DC2 concerns

REPORT
METRO 78
EDMONTON, ALBERTA
WIND IMPACT STATEMENT
PROJECT #: 2100276
APRIL 20, 2022

Basement Units

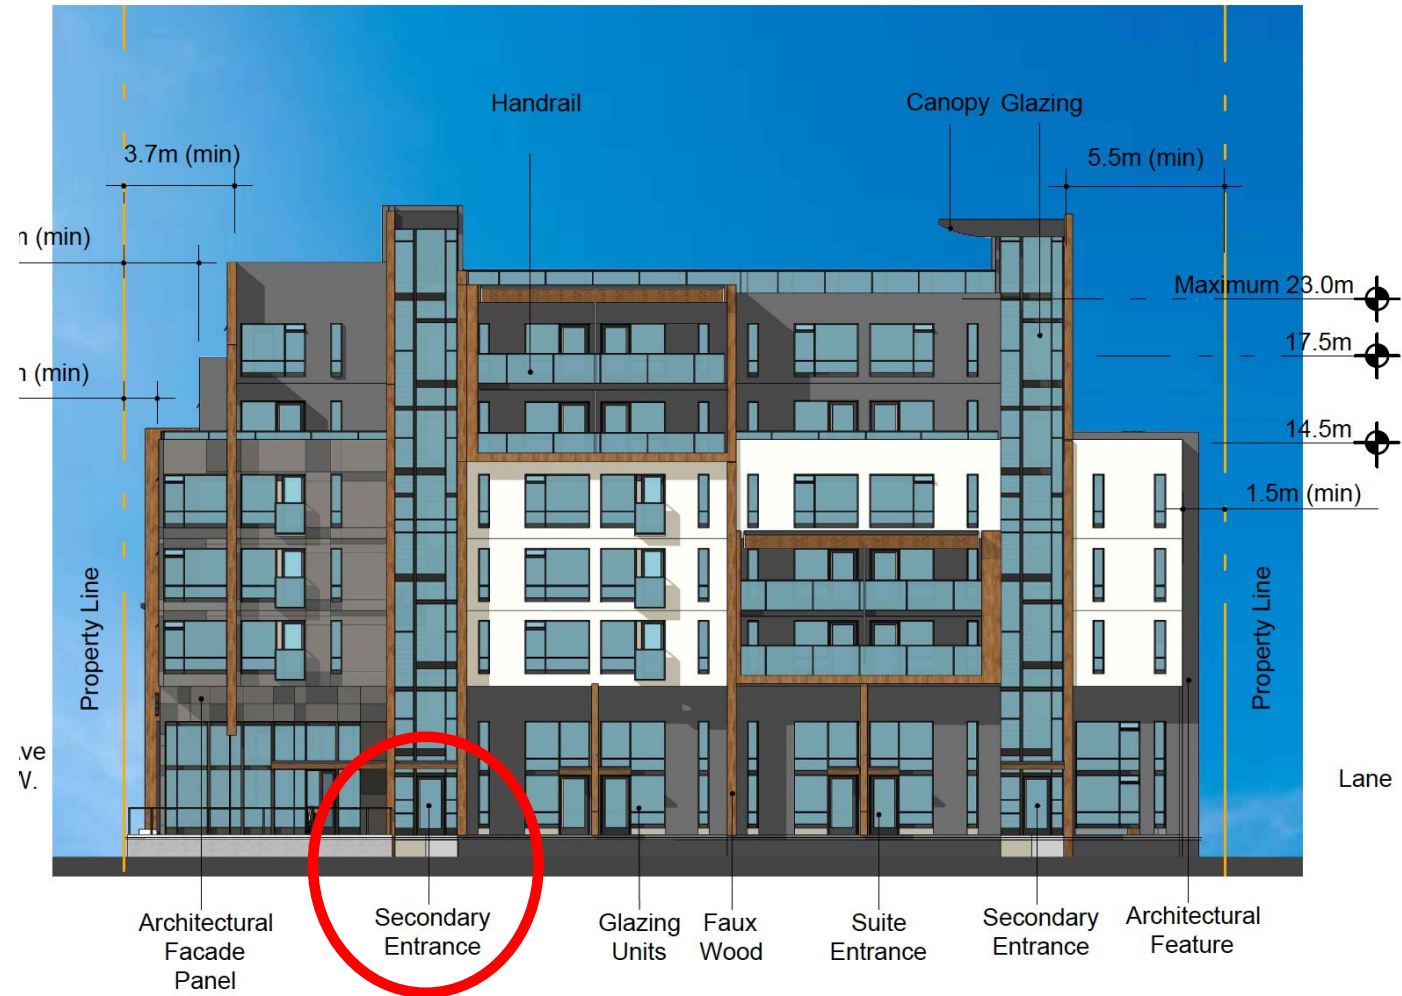
Questions:

- Is the 600 m² of basement units for both Metro78 buildings or will each have 600 m² of basement space?
- How many basement units are intended?
- Why is basement residential space not included in the FAR?
- Is this basement included in the elevations in the final DC2?
- How will the basement impact the height of the other levels?

APPENDIX 8a (South Building)
 - EAST ELEVATION

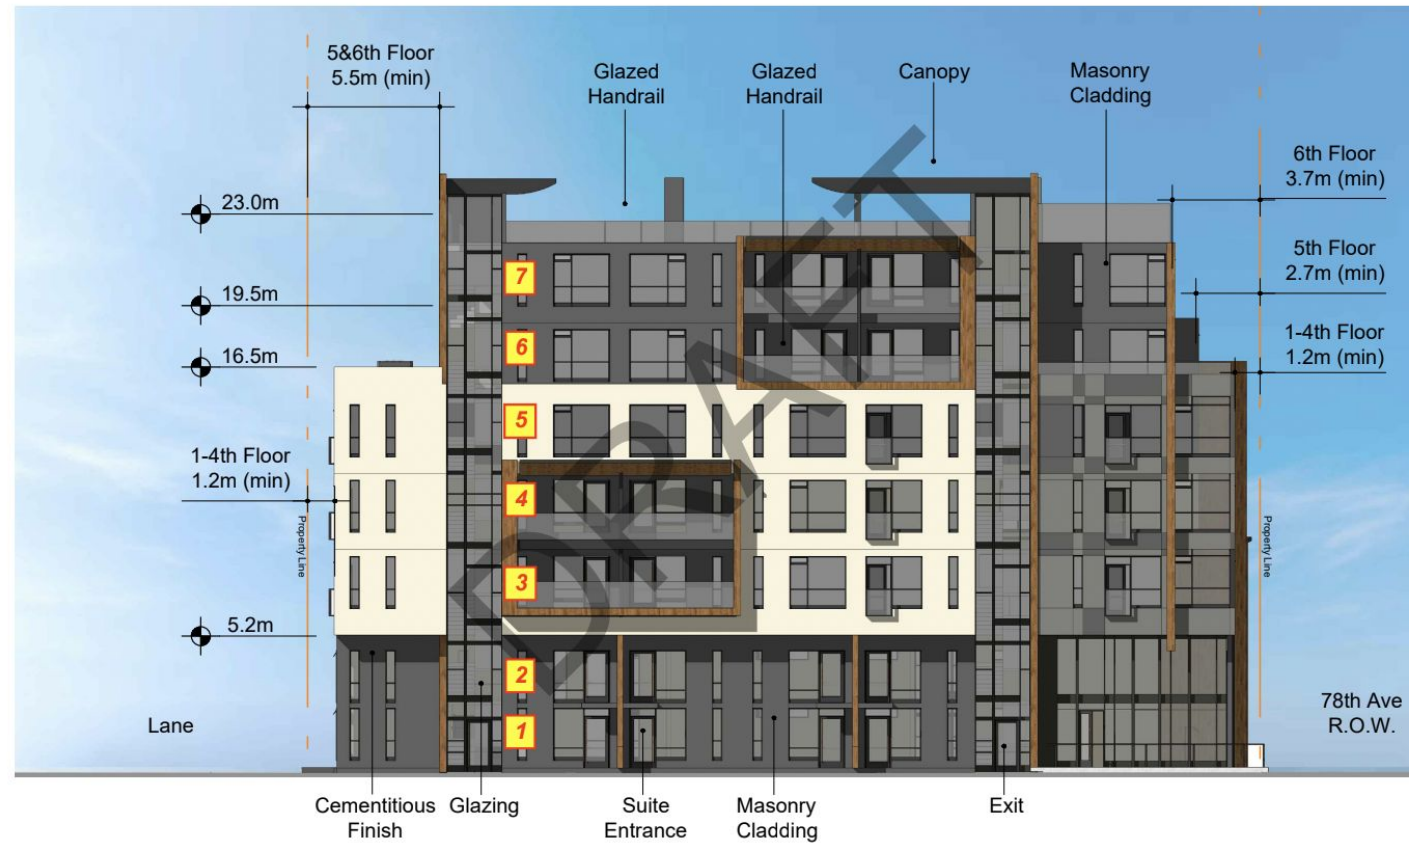
Regarding your question on the number of storeys, I received clarification from the applicants that there was an increase of storeys from six to seven. Along the eastern edge of the buildings, the dwelling units designed for families are proposed with two storeys. This translates to higher ceiling heights for the commercial space (proposed at 1-storey) and floor areas at the western half of the building (also proposed at 1-storey). Based on this information, the building is considered up to 7-storeys but 6 storeys facing west. The applicants have indicated to maintain the proposed maximum height at 23 m.

APPENDIX 8b (South Building)
- WEST ELEVATION

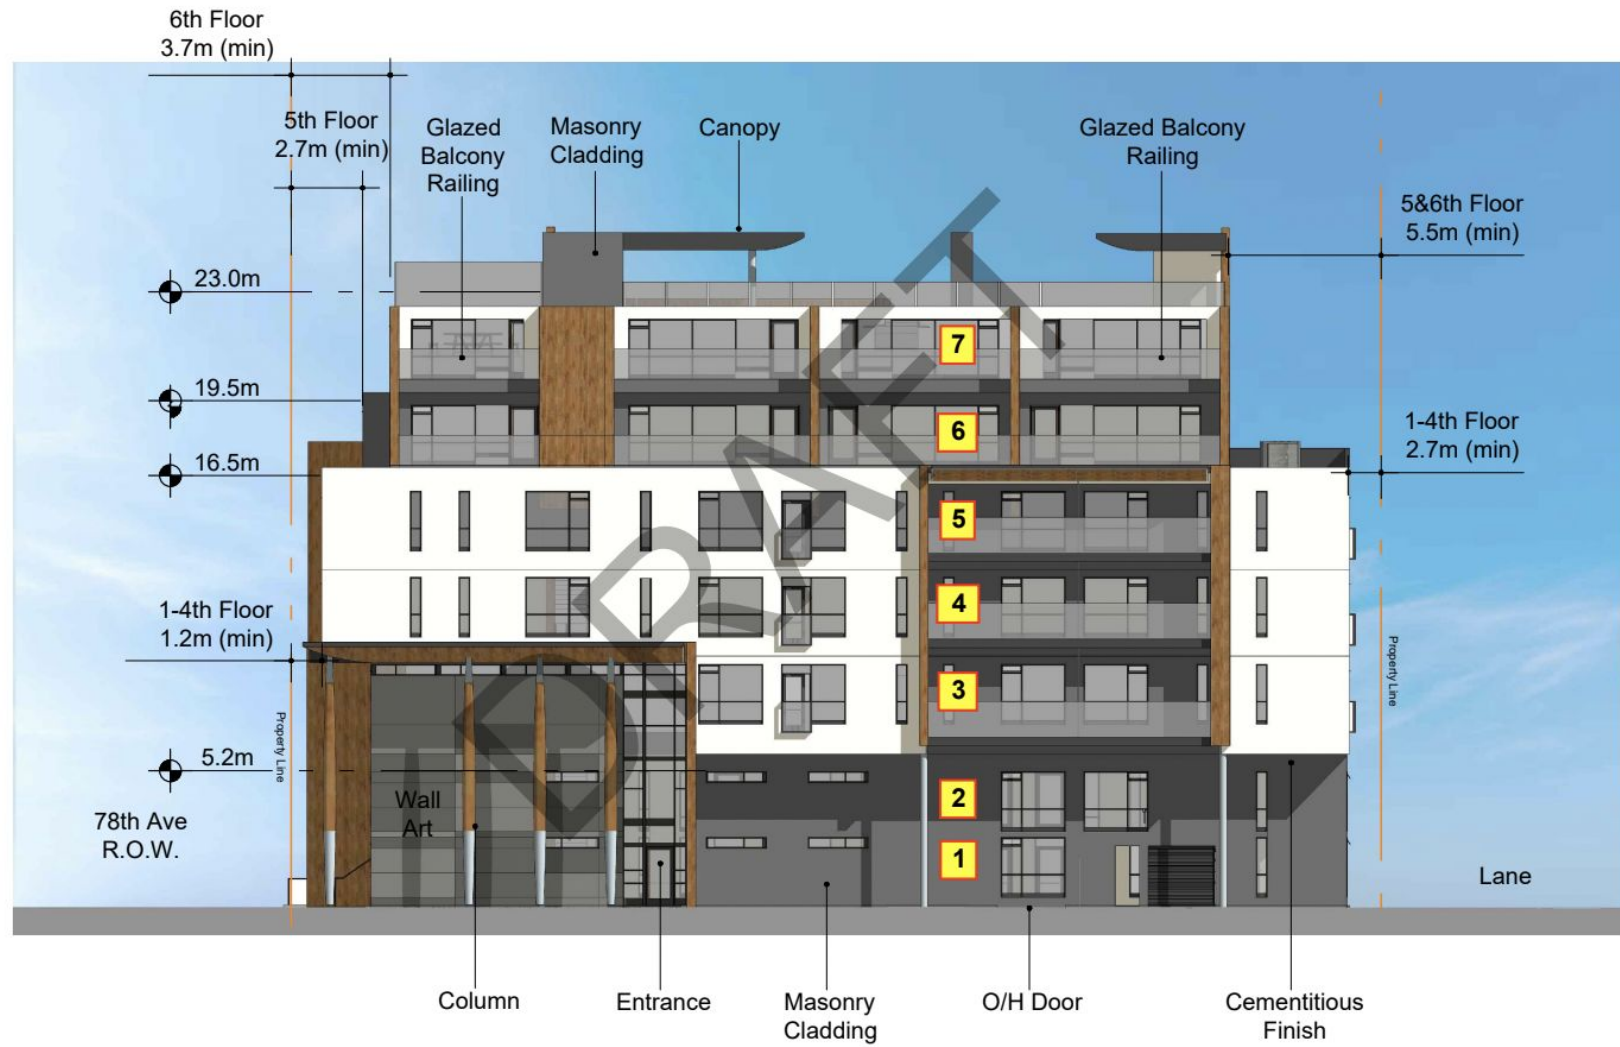
I received clarification from the applicants that all residential units on the main floor will have a second floor in order to meet the requirements to qualify these units designed for families. Based on this, the proposed buildings on all sides are in fact 7-storey structures.

APPENDIX 7a (North Building)
- EAST ELEVATION

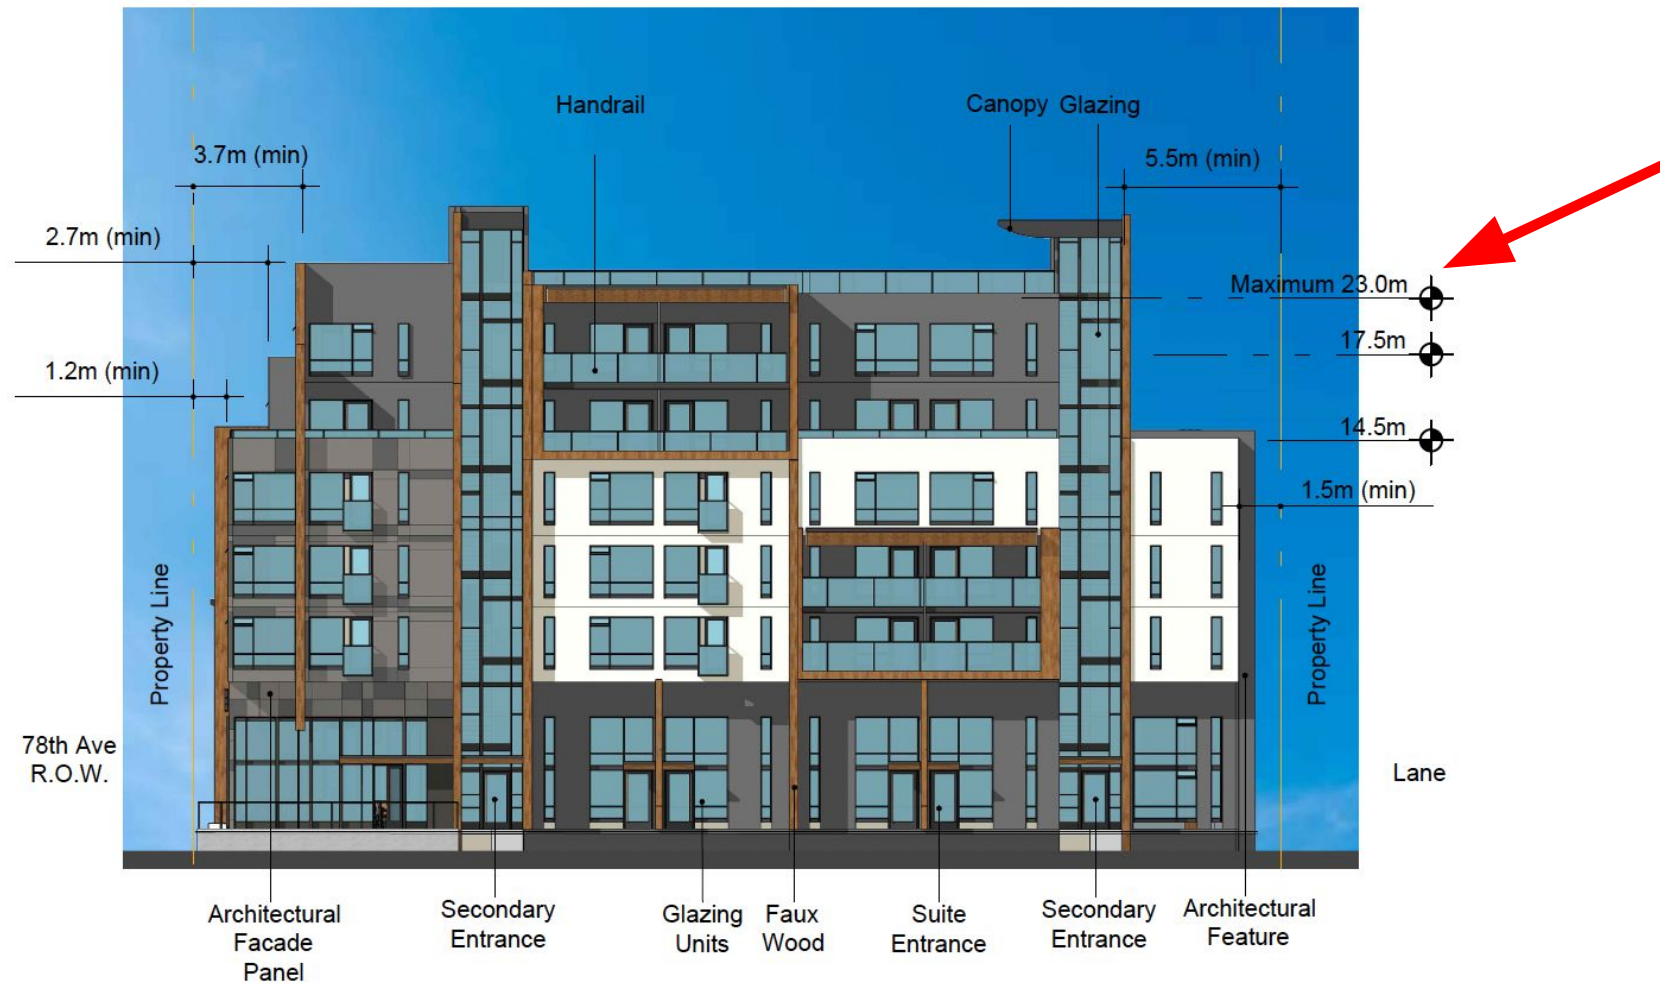
Is this acceptable?
